PROJECT NO. 20123
HOSSACK & ASSOCIATES ARCHITECTS

ADDENDUM NO. 4

Issued March 26, 2021

RE: Prueter Public School – HVAC Upgrades
Kitchener, Ontario

NORTH GROUND FLOOR PLAN - HEATING & VENTILATION
SCALE: 1:100

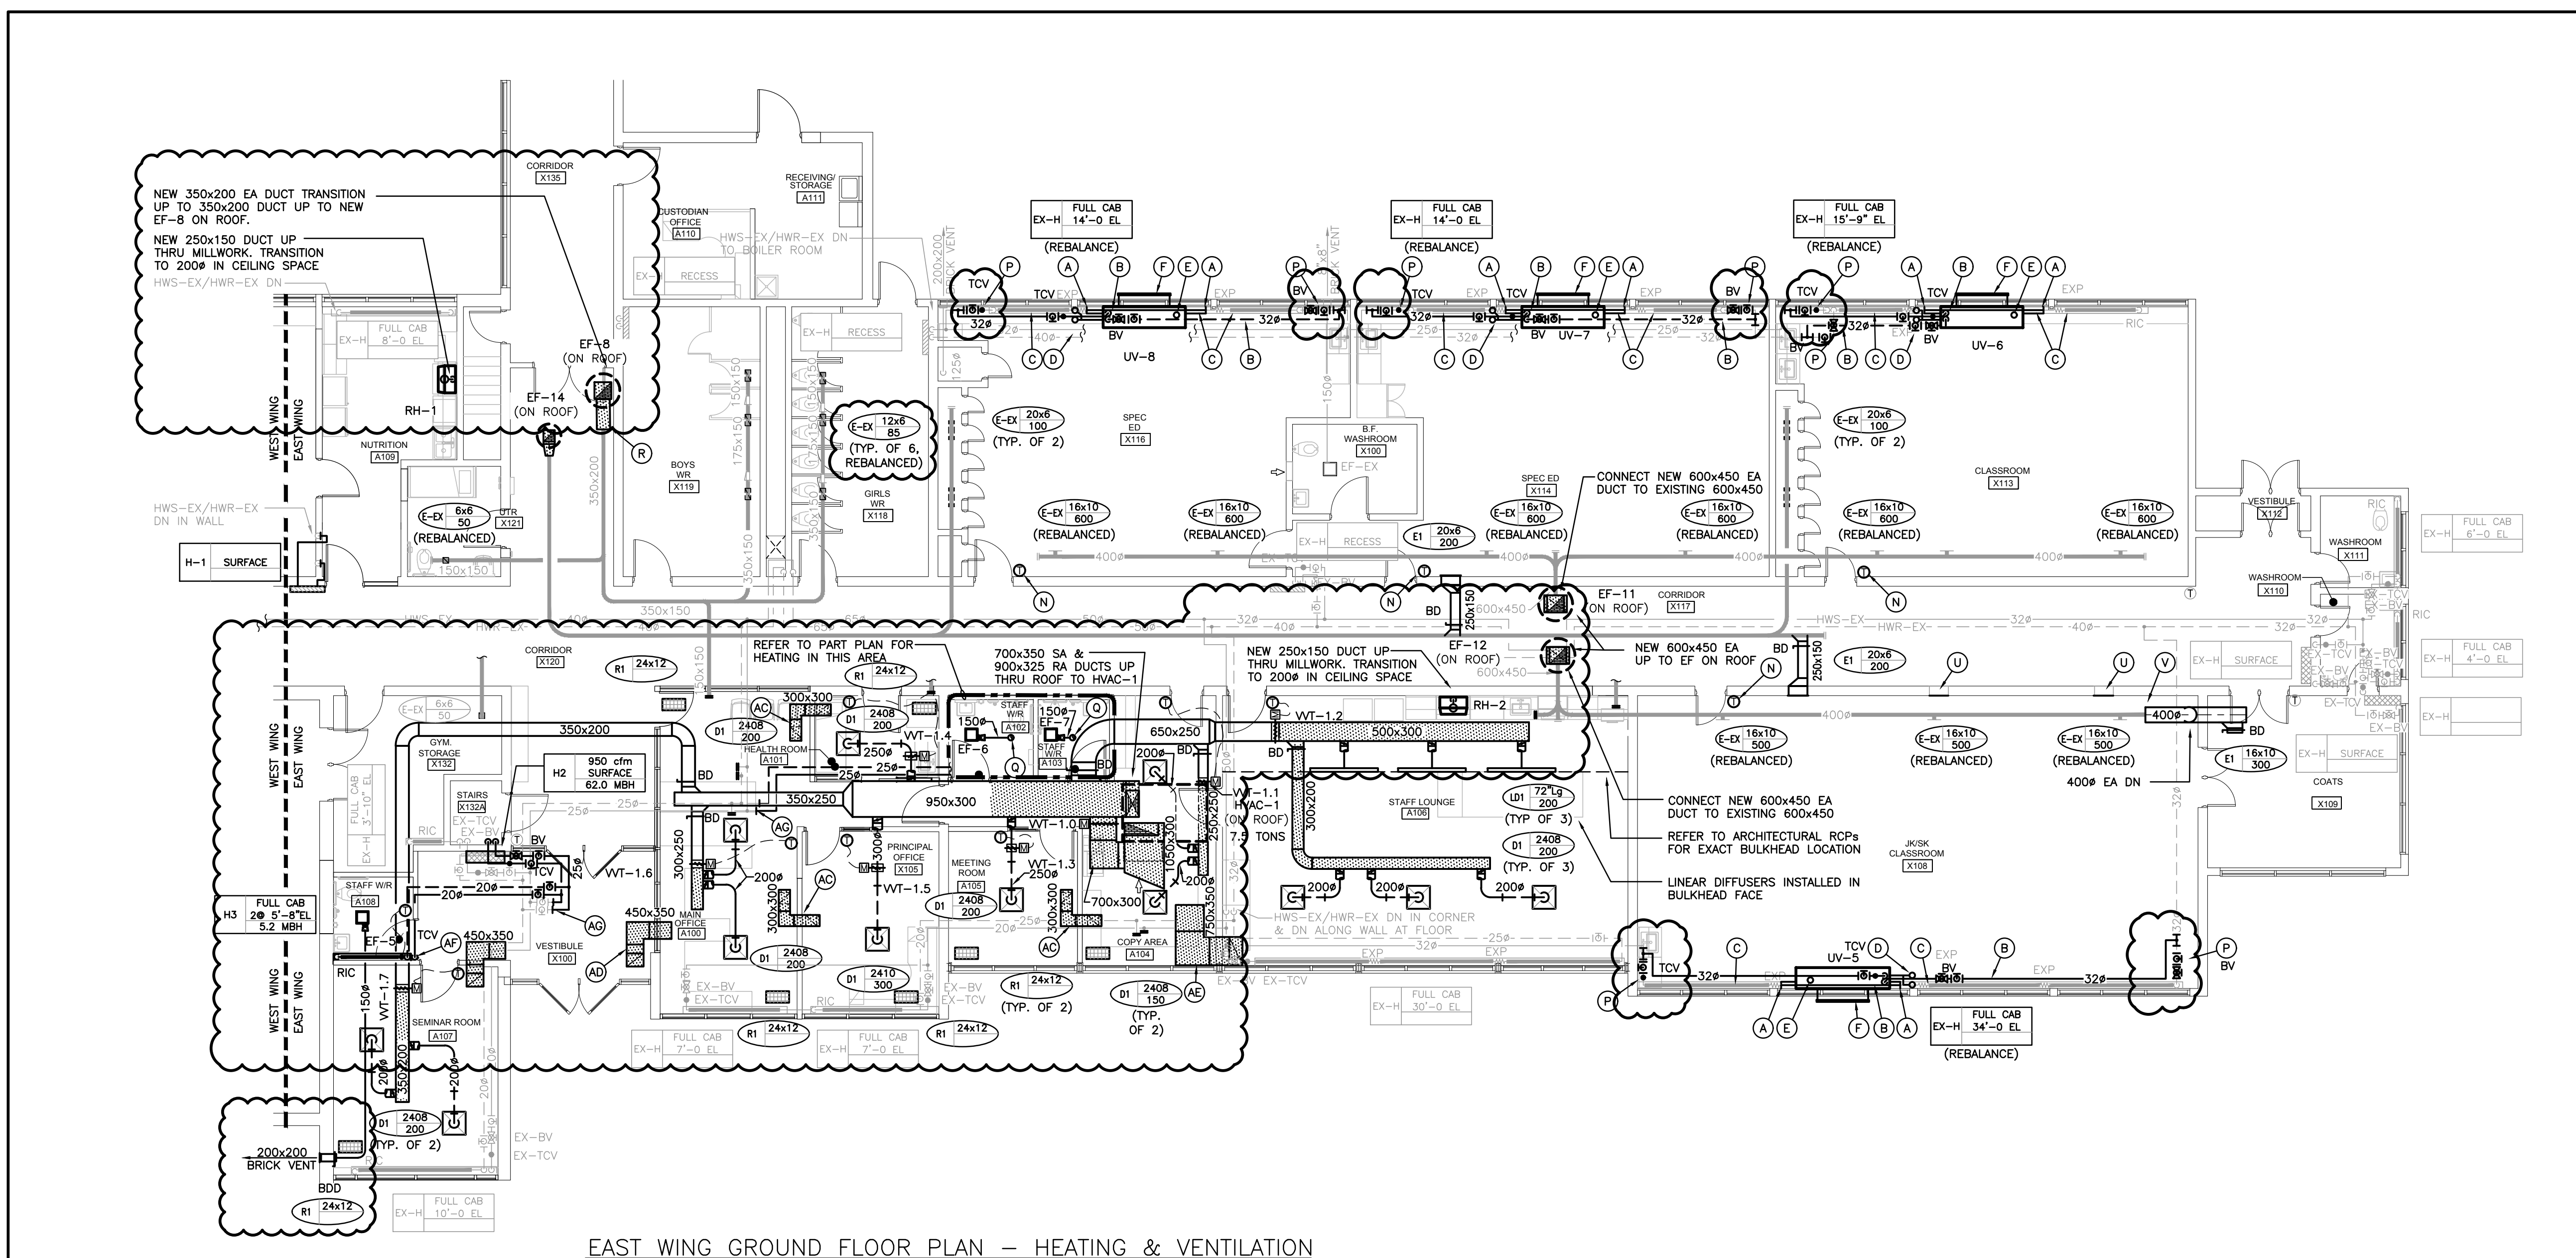
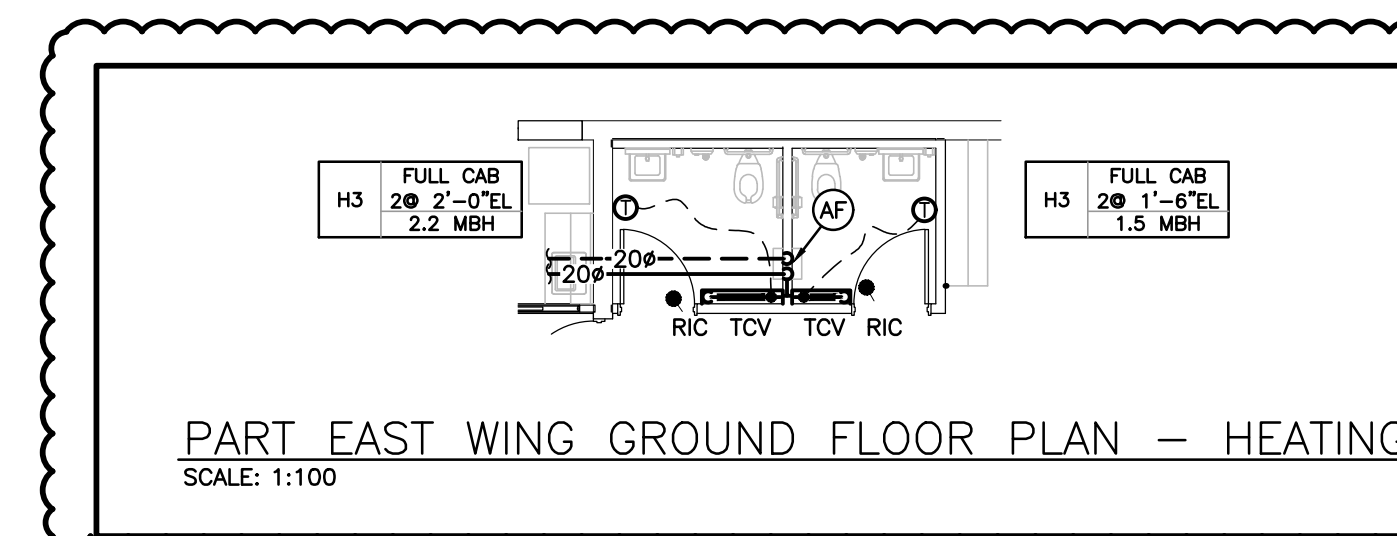
Item 6**6.0 Reference Attached Re-Issued Drawing M06**

- .1 Specific Renovation Notes have been revised. Refer to re-issued drawing M06.
- .2 Provide steel stand to be for UV-1 and UV-4 to suit exterior grade change. Louver to be located at high level in classroom. Refer to re-issued drawing M06.

- .3 Single thermostat added in Library X127 serving UV-13 and UV-14 and radiant heat. Refer to re-issued drawing M06.
- .4 Replace all existing shutoff and balancing valves serving all modified radiant heaters throughout. Refer to re-issued drawing M06.

- .5 Rebalance exhaust grilles in JK/SK X108, Boys WR 119, Girls WR X118, UTR X121 to suit new fans. Refer to re-issued drawing M06.
- .6 Thermostat in Meeting Room A105 relocated. Refer to re-issued drawing M06.

- .7 Return air grilles added in Health Room A101, Principal Office X105, Copy Area A104, Seminar Room A107, Main Office A100, and Meeting Room A105. Refer to re-issued drawing M06.

- .8 VVT and ductwork sizing has been revised. Refer to re-issued drawing M06.
- .9 250x150 duct up thru millwork from RH-1 and RH-2. Transition in ceiling space to 200Ø.

- .10 Provide acoustic insulation on new ductwork leading into EF-8, EF-11, and EF-12. Refer to re-issued drawing M06.
- .11 Run wiring for new thermostats in wire mold to the ceiling and then from ceiling to new unit ventilators and existing radiation units. Refer to re-issued drawing M06.

- .12 H3 units added in Staff Washroom A102, A103 and A108. Refer to re-issued drawing M06.

PIPE SUPPORT ON ROOF

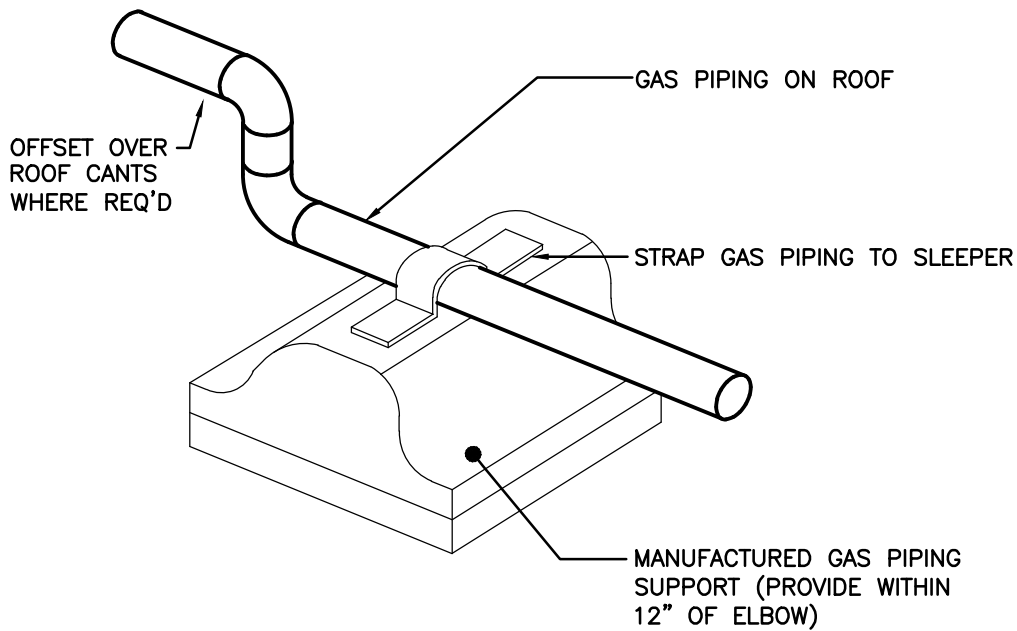
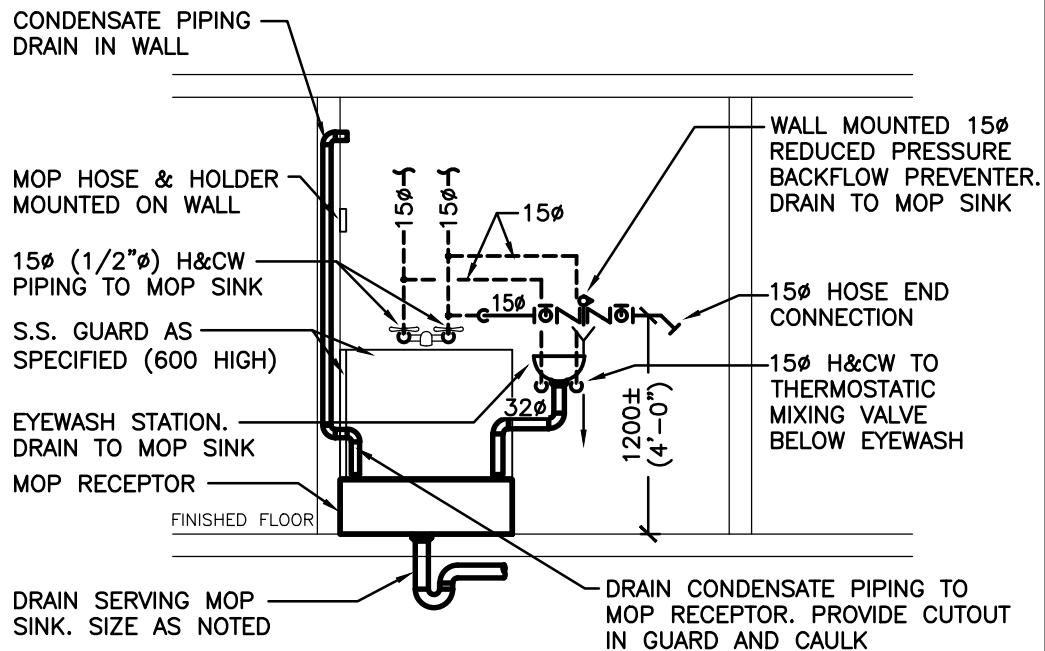
Item 8**8.0 Reference Drawing M08 and Attached Sketch SKM-1**

- .1 Mop sink and pipe support on roof details added. Refer to attached sketch SKM-1.
